## **Coastal Access Modification Report MR2**

Proposed changes to the submitted King Charles III England Coast Path proposals for Isle of Wight 3: Culver Down to Binnel Bay

**Location affected: Shanklin Chine**

Natural England's Modification Report to the Secretary of State

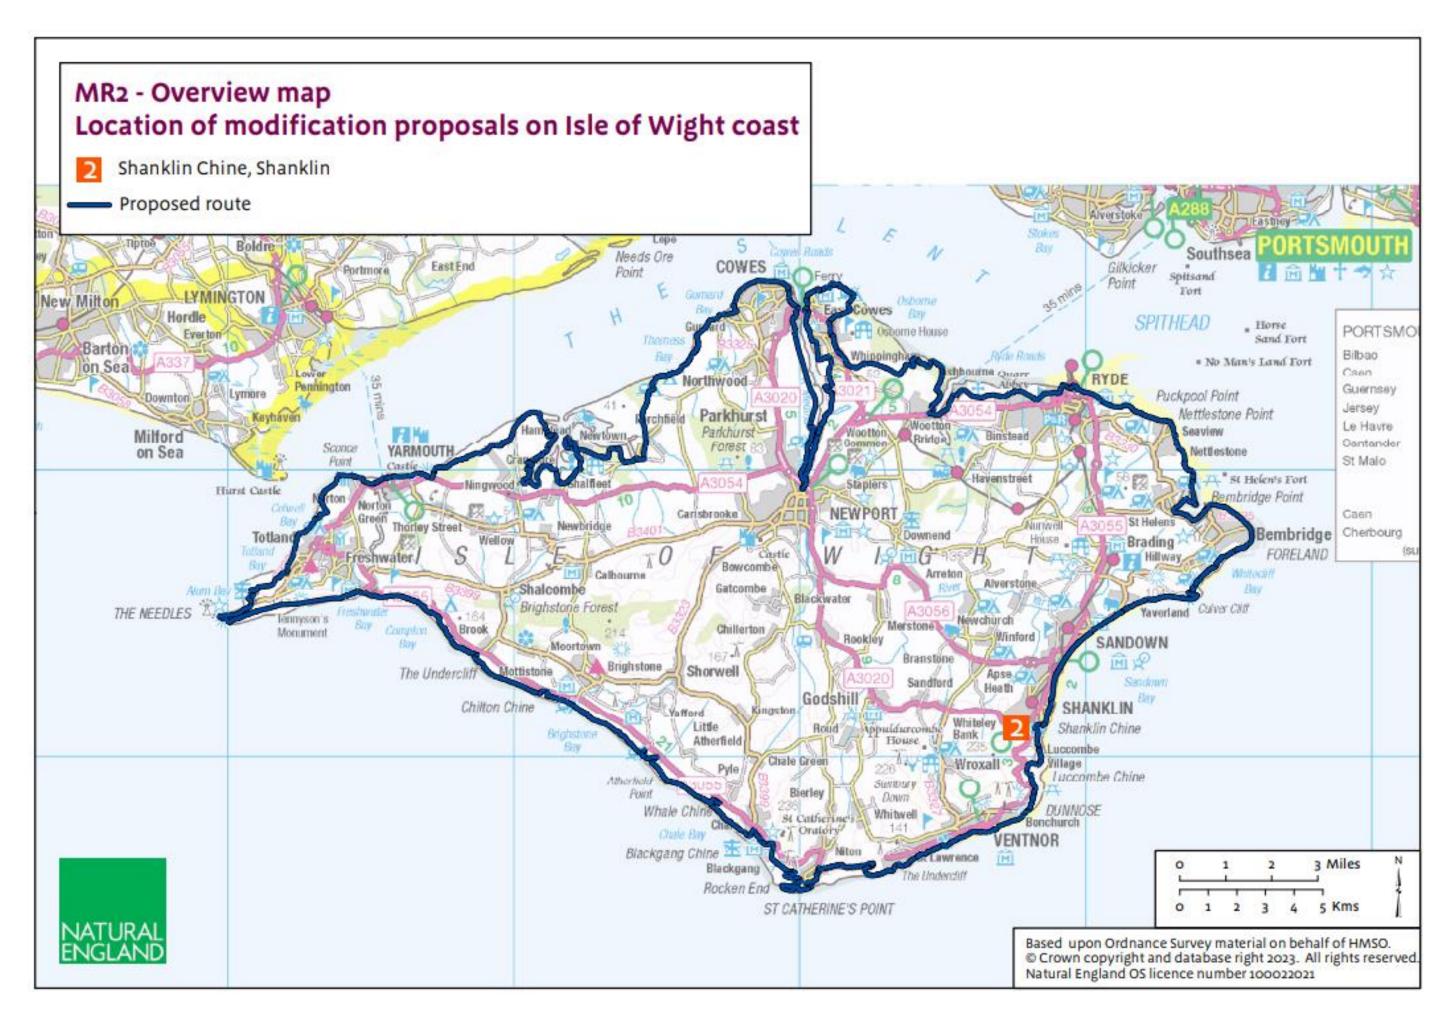
- 1.3 Since submission of its report, it has become clear to Natural England that because of altered circumstances a substantial change is necessary to the route it proposed for the England Coast Path on this stretch.

- 1.4 The change needs to be proposed through a separate Modification Report (MR), so that it can be considered alongside the rest of Natural England's original proposals. The proposed change is at the location shown on the Ordnance Survey base map below headed MR2 Overview Map Location of modification proposals on Isle of Wight coast:

## Map MR2 - Modification 2 - Shanklin Chine

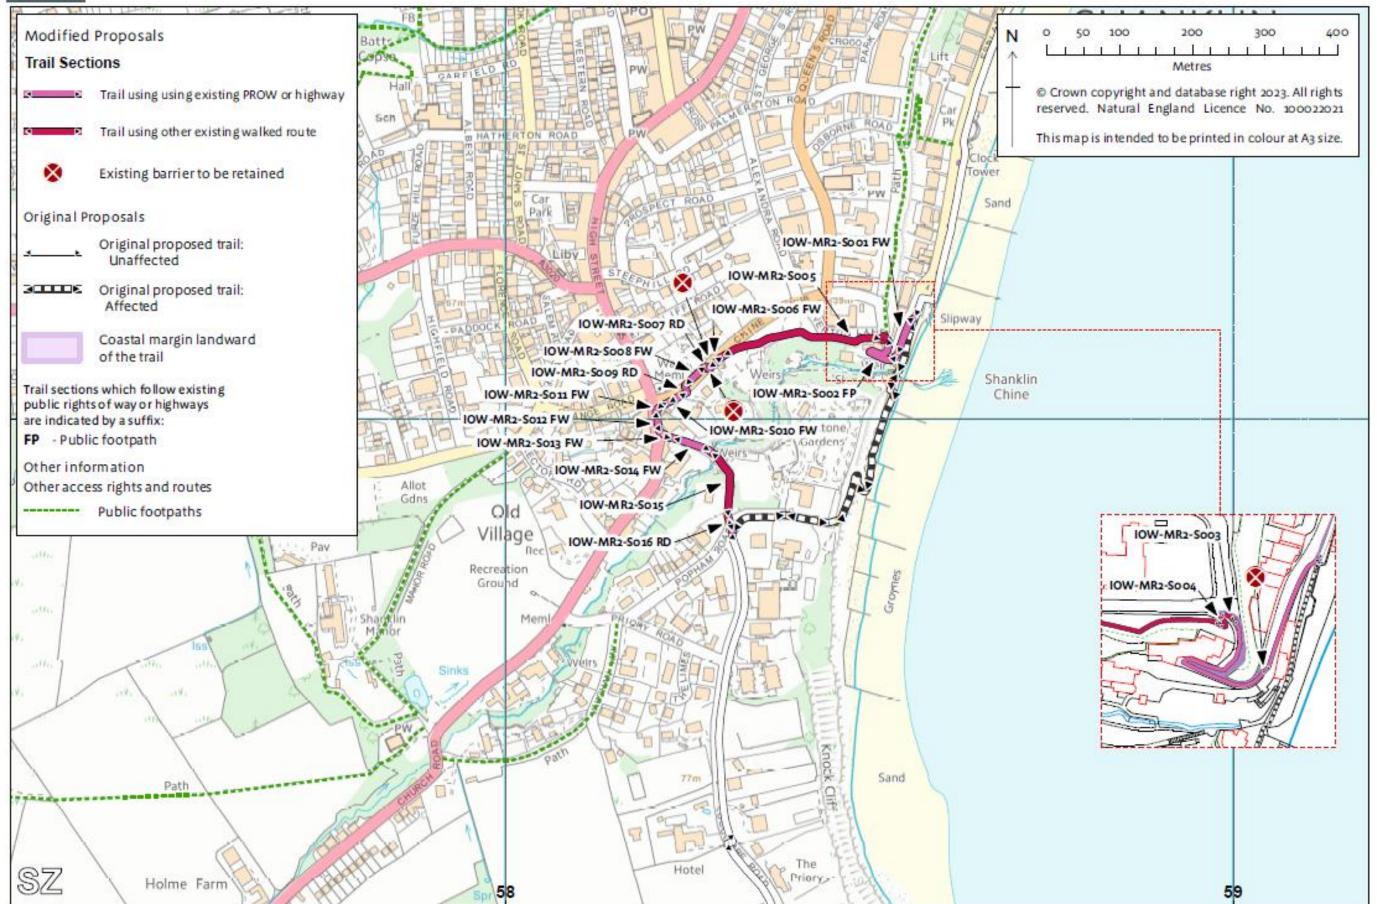
- A.1.1 Our original alignment of the King Charles III England Coast Path (KCIIIECP) in this area, as proposed in Natural England's <u>original report</u>, followed the esplanade before connecting to the beach in front of Shanklin Chine. It then re-joined with the Isle of Wight Coast Path and along Appley Steps.
- A.1.2 Following works to repair Appley Steps due to cliff erosion, heavy rainfall, and further cliff movement meant the route was subject to a further closure. On inspection the route was considered too unstable, and it would require complex engineering intervention and financial input to safely secure the route for public use. It was decided to close Appley Steps whilst a geotechnical survey is carried out by the Isle of Wight Council, a report on which is awaited.

- A.2.1 Our proposal (see Map MR2 Modification 2 Shanklin Chine) is, from north to south, to re-route the path inland from that shown as IOW-3-S033 to IOW-3-S039 in our original report. The length of the realigned trail will be 749m, compared to the original route proposed of 482m.

- A.2.2 The proposed modification to the route:
  - Follows the public footpath along section IOW-MR2-S002
  - Follows 'other existing walked routes' along sections IOW-MR2-S003 to IOW-MR2-S005 and IOW-MR2-S015

- Follows the public highway along sections IOW-MR2-S007, IOW-MR2-S009 and IOW-MR2-S016
  - Follows the public footway (pavement) along sections IOW-MR2-S001, IOW-MR2-S006, IOW-MR2-S008 and IOW-MR2-S010 to IOW-MR2-S014

- Skirts the boundary of Shanklin Chine (geological feature and tourist attraction)
  - Is aligned through Tower Cottage Gardens along section IOW-MR2-S005

- Re-joins the original trail part-way along section IOW-3-S039
